TECHNICAL BULLETIN

407-20-136

MODEL AFFECTED: 407

SUBJECT: AUTOMATIC FLIGHT CONTROL SYSTEM (AFCS)
WIRING INSTALLATION, MODIFICATION OF.

Figure 1 – Locating Rail Assembly 8TB1

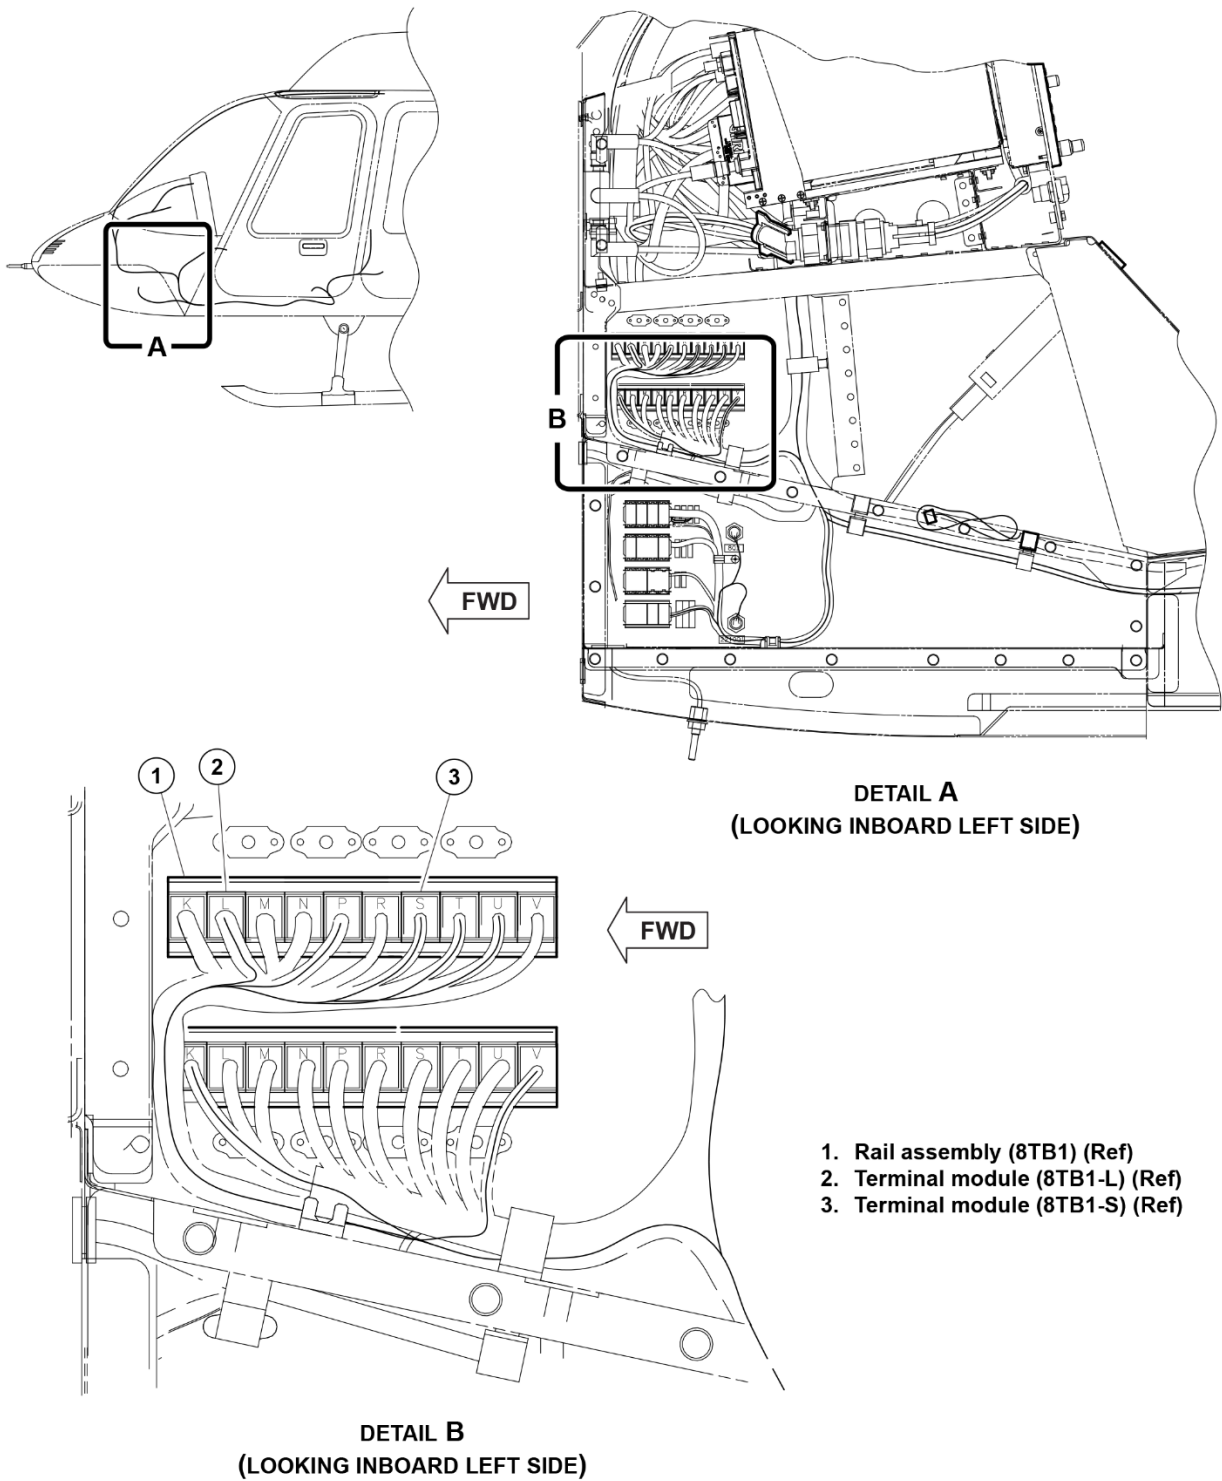
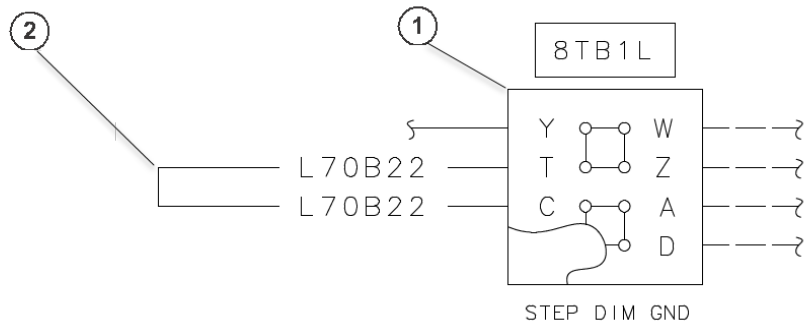
1. Prepare the helicopter for maintenance.
2. Gain access to rail assembly 8TB1 (1, Figure 1).

Figure 2 – Wiring Changes to Rail Assembly 8TB1

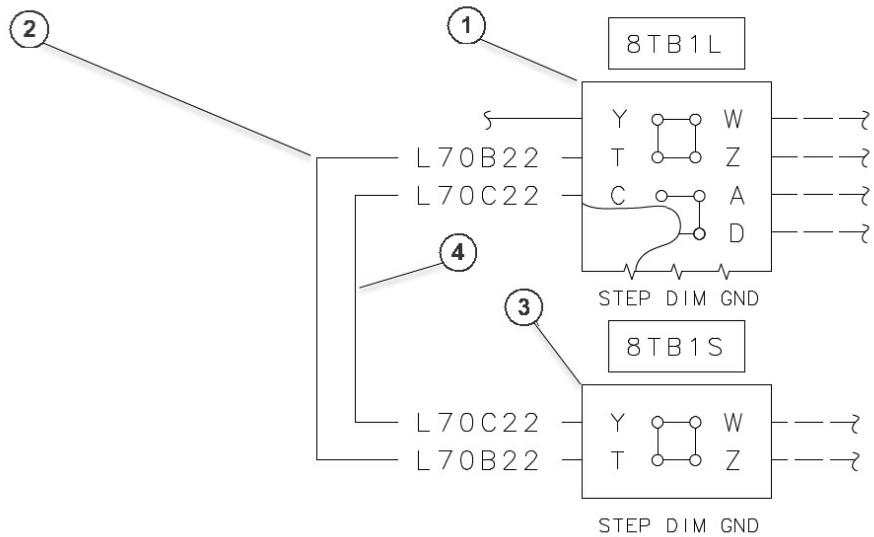
3. Cut two (2) pieces of copper alloy wire seven inches long. Add a contact M39029/22-191 to each end of the wires using crimping tool (BHT-ELEC-SPM, Chapter 5).
 - a. Identify one wire as L70B22 and one wire as L70C22.
4. Locate wire L70B22 (2, Figure 2) on terminal module 8TB1-L (2, Figure 1 and 1, Figure 2).
5. Using the installation/removal tool, remove and discard wire L70B22 (2, Figure 2) from the terminal module (8TB1-L) (2, Figure 1 and 1, Figure 2) between pin C and pin T.
6. Using the installation/removal tool, insert one end of wire L70C22 (4, Figure 2) in pin C of the terminal module 8TB1-L (2, Figure 1 and 1, Figure 2) and the other end of wire L70C22 (4, Figure 2) in pin Y of the terminal module 8TB1-S (3, Figure 1 and 3, Figure 2).

7. Using the installation/removal tool, insert one end of new wire L70B22 (2, Figure 2), created in step 3, in pin T of the terminal module 8TB1-L (2, Figure 1 and 1, Figure 2) and the other end of wire L70B22 (2, Figure 2) in pin T of terminal module 8TB1-S (3, Figure 1 and 3, Figure 2).
8. Secure installed wires L70B22 (2, Figure 2) and L70C22 (3, Figure 2) with cable ties or lacing (BHT-ELEC-SPM, Chapter 6).
9. Install all removed parts or components that were required to gain access to the rail assembly 8TB1 (1, Figure 1).
10. Make an entry in the helicopter logbook and historical service records indicating compliance with this Technical Bulletin.

Removal of wire L70B22 from pin C and T of terminal module 8TB1-L

Installation of new wire L70B22 and wire L70C22 between terminal modules 8TB1-L and 8TB1-S
